Table 6.2.1-2 Basic Specifications of PCCV

Figure 6.2.1-5 Containment Sectional View

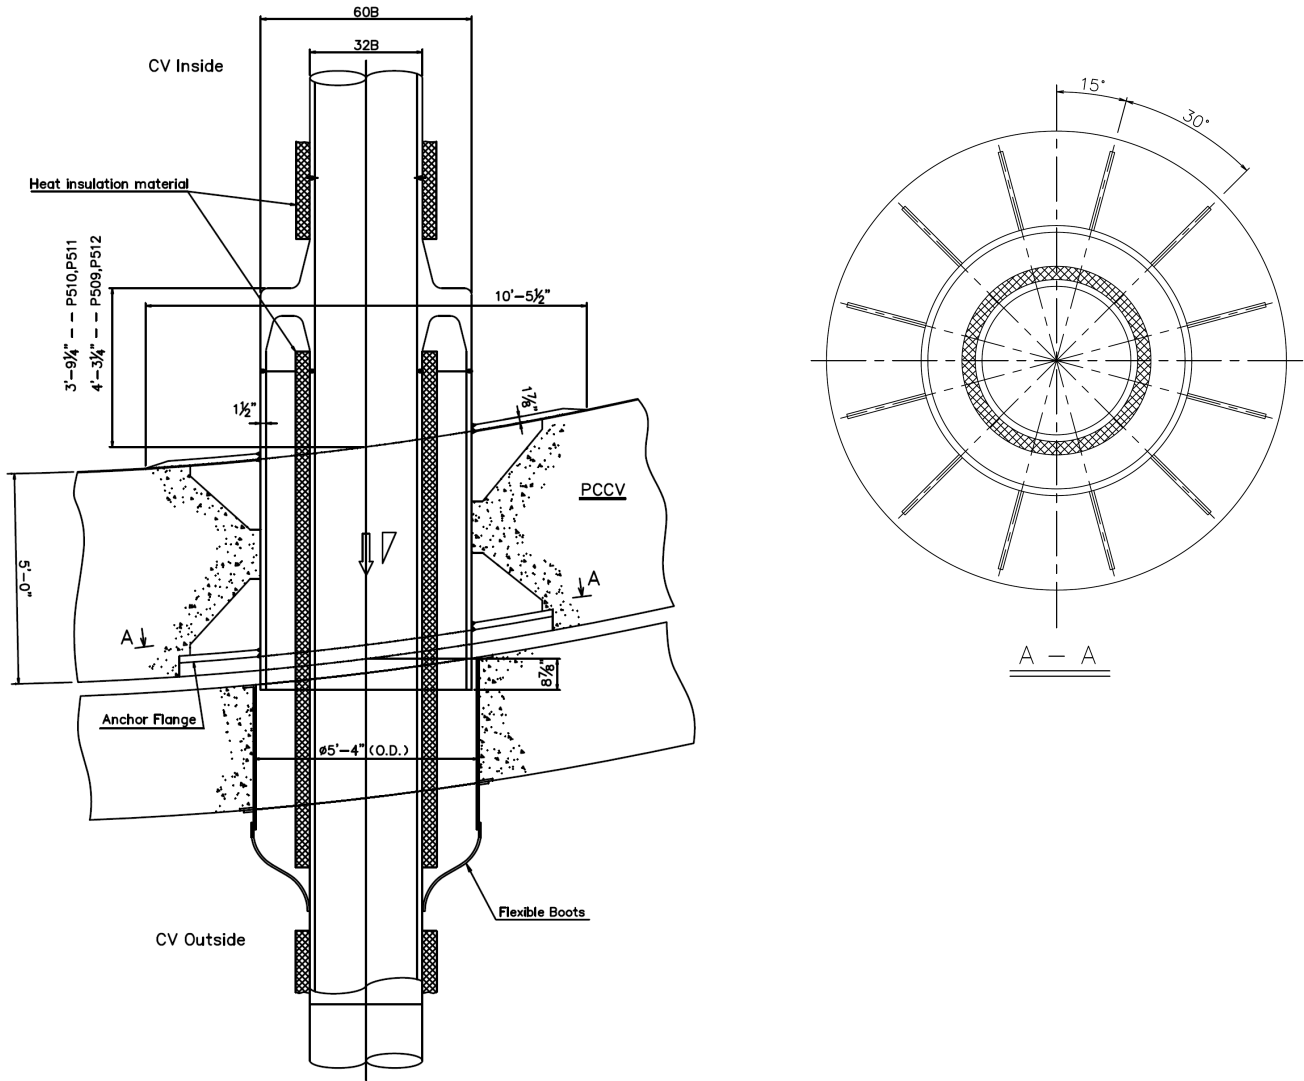
MIC-03-
06-00072

Figure 6.2.1-6 Main Steam Line Penetrations

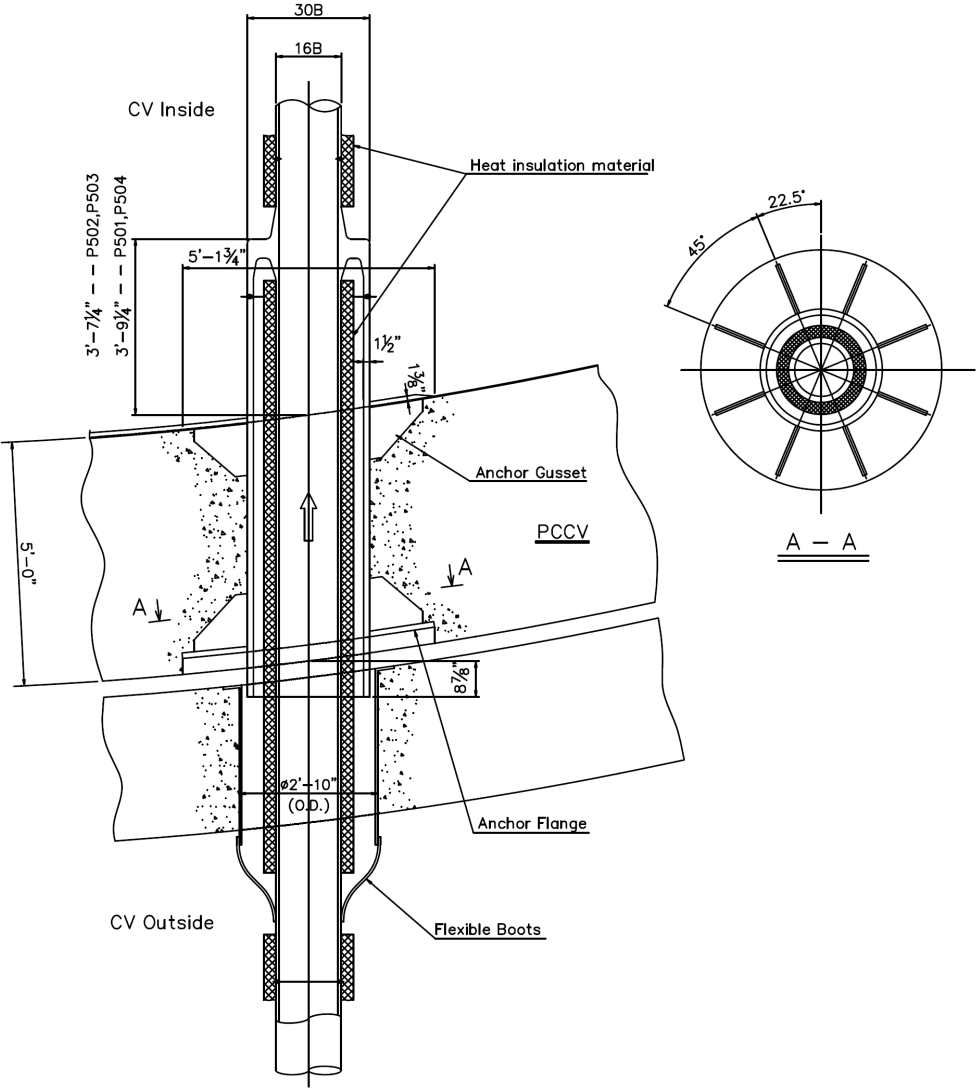
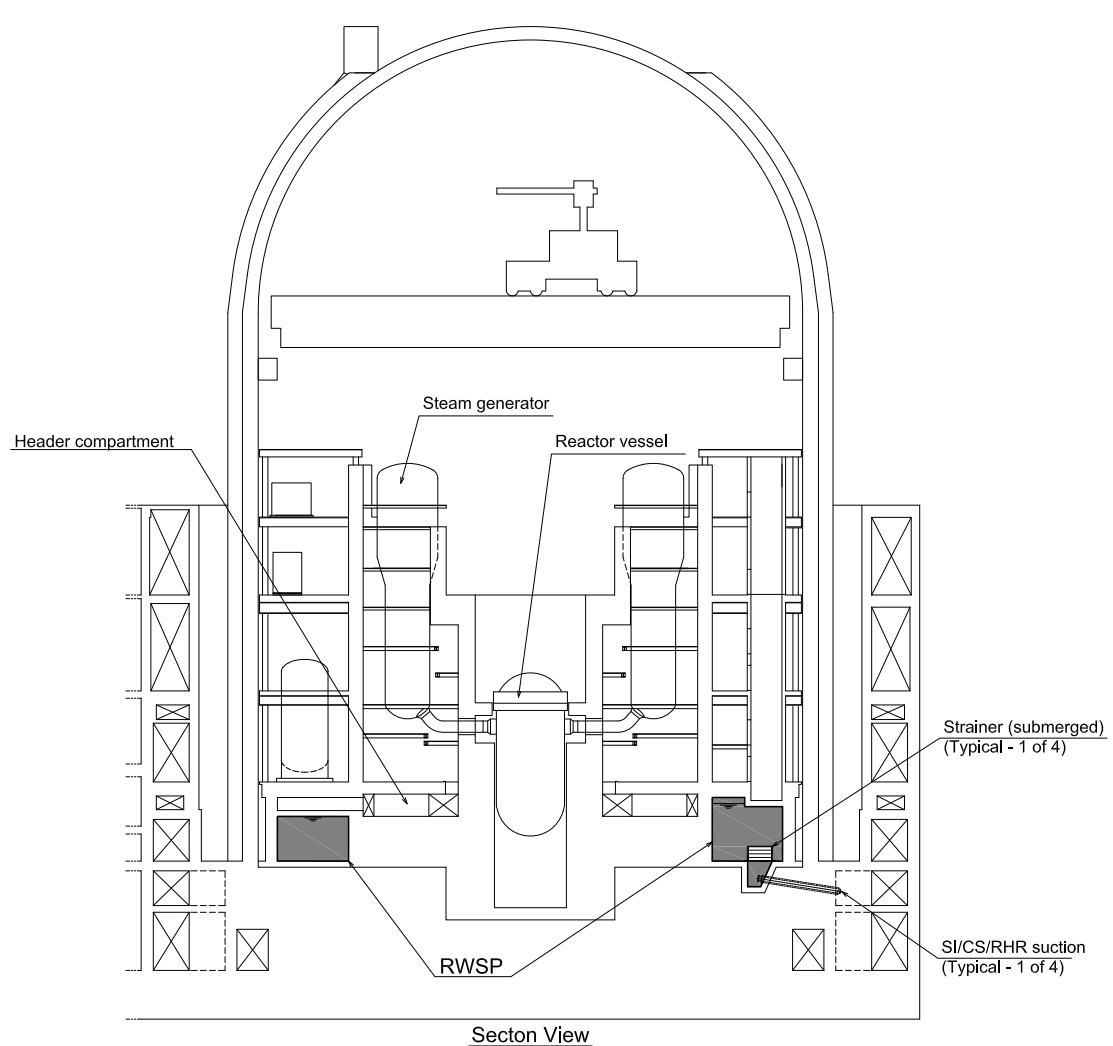
MIC-03-06-00072
